Poor Rated Supplier -Management Review Meeting

**Supplier Name:-
M/s TIDC**

TIDC INDIA FINE BLANKING	<u>CORRECTIVE ACTION PLAN IN 6 W - 2H FORMAT</u> Month - June 22
---	--

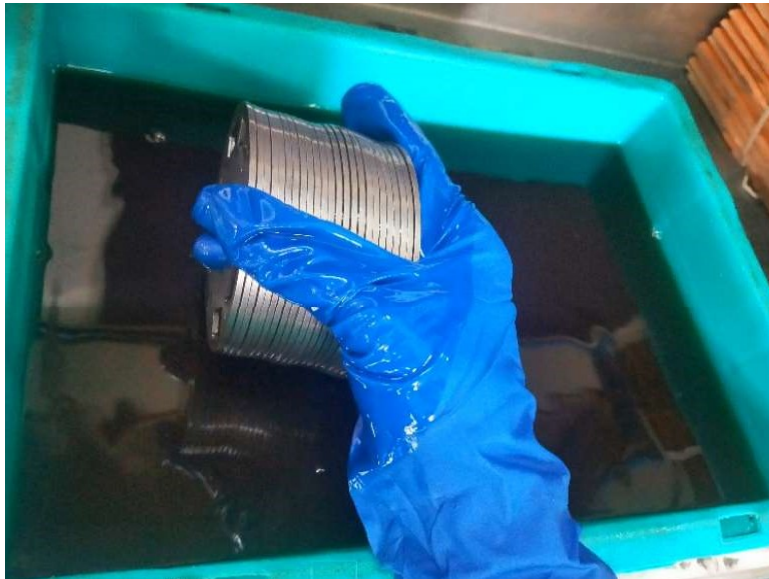
Problem

Current vibro process timing is not effective

Vibro process increased from 1 hr to 2 hrs and daubert Nox rust 307 oil will be used instead of DW904 to avoid part contamination due to oil mixup.
